Re: Review of Stormwater Management Plan at 150 Gundy Road, Scone

Northrop Consulting Engineers have been engaged by Upper Hunter Shire Council (UHSC) to review the Stormwater Management Plan prepared for the proposed development (DA163/2017) at 150 Gundy Road, Scone.

NL213311 / 19 January 2022 / Revision A

Drawn	Date	Scale	A1	Q.A. Check	Date
ADS	MAR 2021	N.T.S.	UK	12.03.21	
Designed	Project No.	Issue	Figure	Issue	
UK	NSW202732	FIGURE 4	B

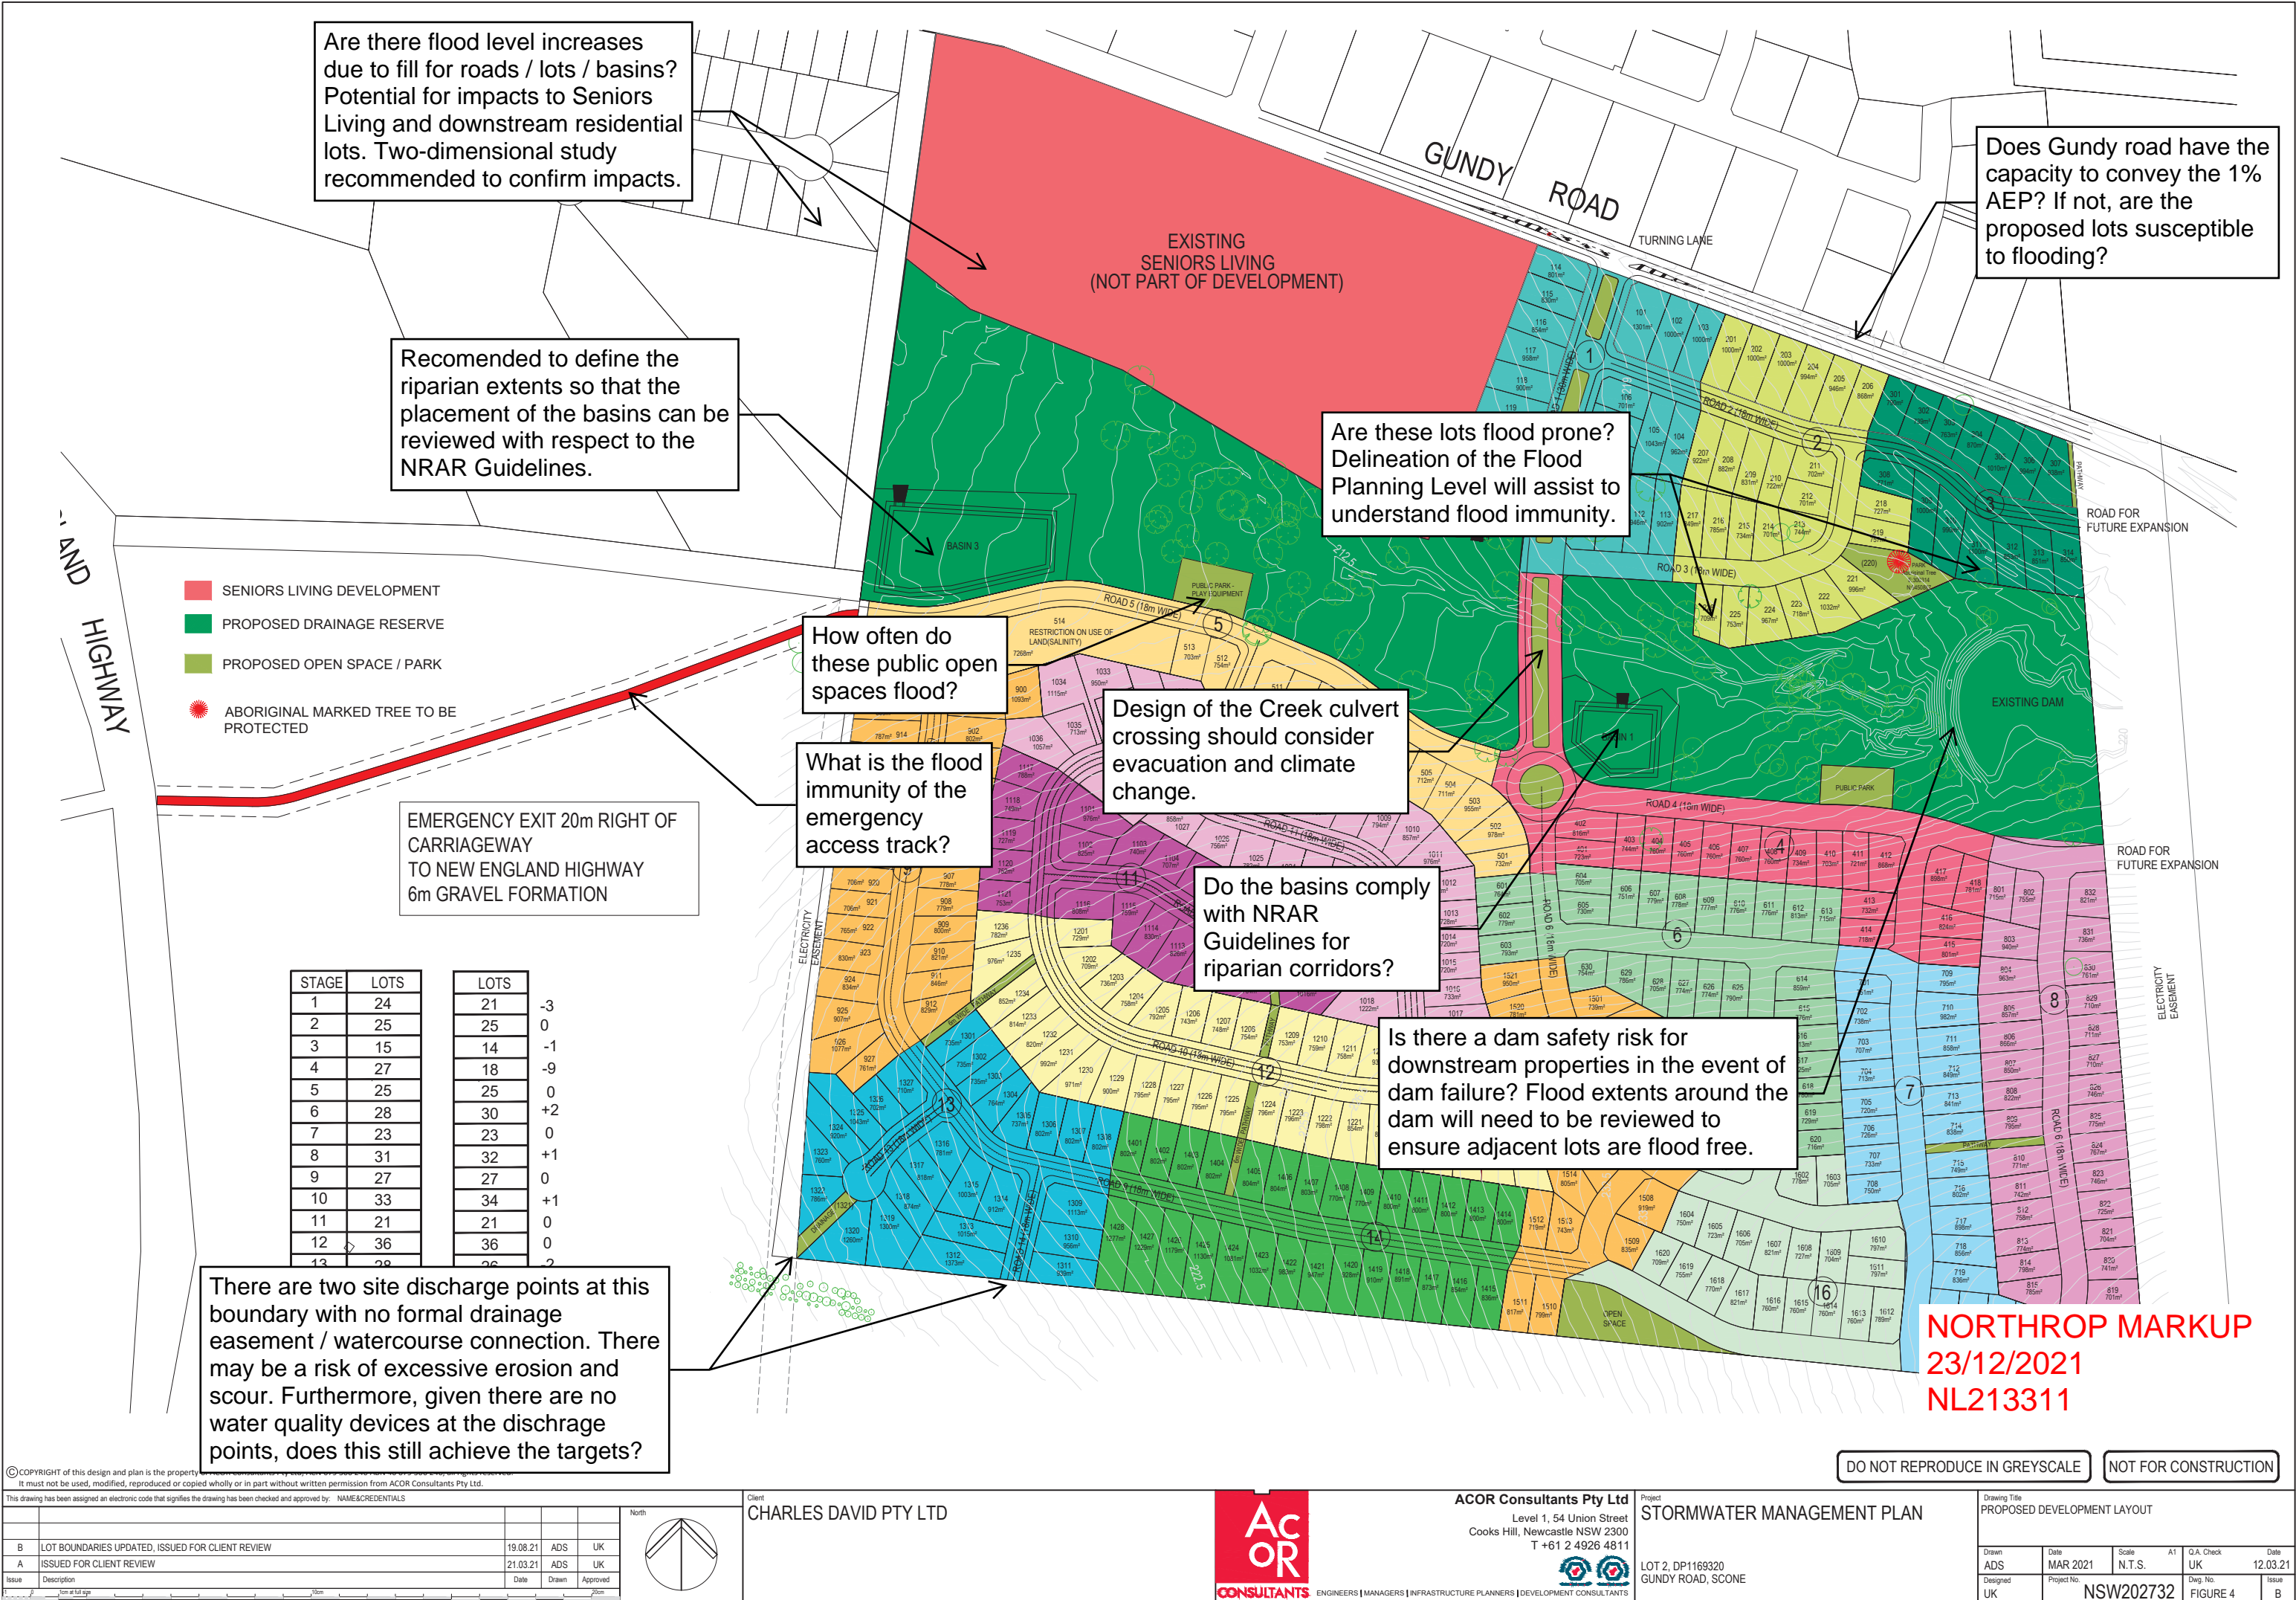
A review of the proposed Concept Stormwater Management Plan (ACOR, 2021) has been prepared with comments presented in **Figure 1** and summarised below.

The Stormwater Management Plan (ACOR, 2021) refers to the MM Hyndes Bailey report (2017) for the flood extents through the second order creek. The modelling presented in the MM Hyndes Bailey report (2017) has been prepared with flows derived using the Regional Flood Frequency Estimation tool and flood extents determined using HEC-RAS.

As previously discussed, peak flows are considerably higher in the Stormwater Management Report (ACOR, 2021) than the MM Hyndes Bailey report (2017). The modelling has also been prepared based on an old layout with the flood extents not reflective of the development layout presented in the Stormwater Management Report (ACOR, 2021).

Following a review of the above studies, we are unable to accurately determine the extent of the 1% AEP flood event and evidently the extent of the Flood Planning Area for the proposed layout. This information is required to determine whether the proposed lots, roads and infrastructure are susceptible to flood and whether they are sited in accordance with the LEP / DCP / NSW Floodplain Development Manual.

In addition, it is possible the section of the development located on the southern side of the creek may become a high flood island during a major / extreme flooding event. An emergency exit track from the development is proposed however, it is not possible to determine the flood immunity of this track from the documentation provided. It is recommended the design of emergency access track, or the creek culvert crossing be reviewed with consideration to risk to life and evacuation from this area.

As mentioned, the MM Hyndes Bailey report (2017) reviews an old development layout and does not consider existing case flood behaviour. As such, it is not possible to determine if there are any adverse flood impacts due to fill for roads, lots and the bio retention basins within the existing second order creek.

There are sensitive sites adjacent to the proposed development, namely the senior's living village (HammondCare Strathearn House) as well as residential properties downstream. We recommend a two-dimensional flood study be prepared using the latest developed layout to confirm whether there are any significant adverse flood impacts in these properties. This study may also be used to verify the requirement for no stormwater detention for the proposed development.

Furthermore, Section 3.4 of the Stormwater Management Report (ACOR, 2021) highlights the potential for the existing road-side swales in Gundy Road to overtop during major events. An assessment on the capacity of Gundy Road to convey overland flow during the 1% AEP should be prepared and stormwater upgrades proposed as necessary to ensure the proposed lots fronting Gundy Road are not flood prone.

There is an inconsistency in the size of the creek culvert crossing between the MM Hyndes Bailey (2017) report and those proposed in the Stormwater Management Report (ACOR, 2021). Each report suggests the following:

- MM Hyndes Bailey (2017): 10 x 1500mm x 750mm
- Stormwater Management Report (ACOR, 2021): 11 x 2400mm x 750mm

This discrepancy should be discussed in the Stormwater Management Report (ACOR, 2021) with consideration to the risk to life and evacuation requirements as discussed in the above flooding section.

Furthermore, it is unclear whether blockage has been considered in the design of the proposed culvert crossing. Similarly, it is not possible to determine the flood immunity and available freeboard to the culvert crossing under today's and future climate scenarios. These should be discussed in the Stormwater Management Report (ACOR, 2021).

The Stormwater Management Report (ACOR, 2021) suggests the creek bisecting the proposed development is a second order watercourse. The applicant should address whether the proposed bio-retention basins, that are to be placed adjacent to the watercourse, comply with the NSW Natural Resources Access Regulator (NRAR) guidelines for Controlled Activities on Waterfront Land.

Riparian extents are not presented in the documentation and as such, it is not possible to assess the NRAR requirements with the information provided.

There are two site discharge points in the south-western corner of the site; one discharging into the electrical easement and another to connect to a future road corridor. From the information provided, it does not appear that these outlets connect to a formal drainage easement or watercourse connection.

Without a formal drainage connection, there is a risk of excessive erosion and scour downstream of these discharge points. The applicant should review whether mitigation measures are required to ensure the downstream ecosystem, road and stormwater infrastructure, farms and properties are not adversely impacted.

Furthermore, there are no end of line water quality devices proposed at this location (GPT / Bio-retention). As this catchment discharges to a separate watercourse, the water quality assessment should confirm that the treatment targets can be met at each site discharge point.

Section 3.5 notes that the existing farm dam is to remain as part of the development. The applicant should consider whether there is a dam safety risk for the proposed and existing properties downstream of the dam in the event of failure.

Similarly, an access track will be required to ensure the condition of the dam can be assessed and maintained as required.

Presented below is a summary of the recommended updates to the Stormwater Management Strategy (ACOR, 2021).

- Model hydrology should be updated to consider the use of the latest NSW Specific Rainfall Losses and Hierarchy Approach recommended by NSW OEH and the ARR 2019 EIA/ ICIA split.

- Definition of riparian extents should be prepared and placement of Water Quality devices in accordance with NRAR Controlled Activities on Waterfront Land guidelines should be reviewed.

- The design for the creek culvert crossing should be reviewed with respect to blockage and climate change and the difference in sizing with previously completed studies for the area should be discussed.

- The proposed evacuation access track and/ or culvert crossing should be reviewed with respect to risk to life and evacuation.
- The difference between peak flows observed in the Stormwater Management Plan (ACOR, 2021) and other similar studies in the area should be discussed.
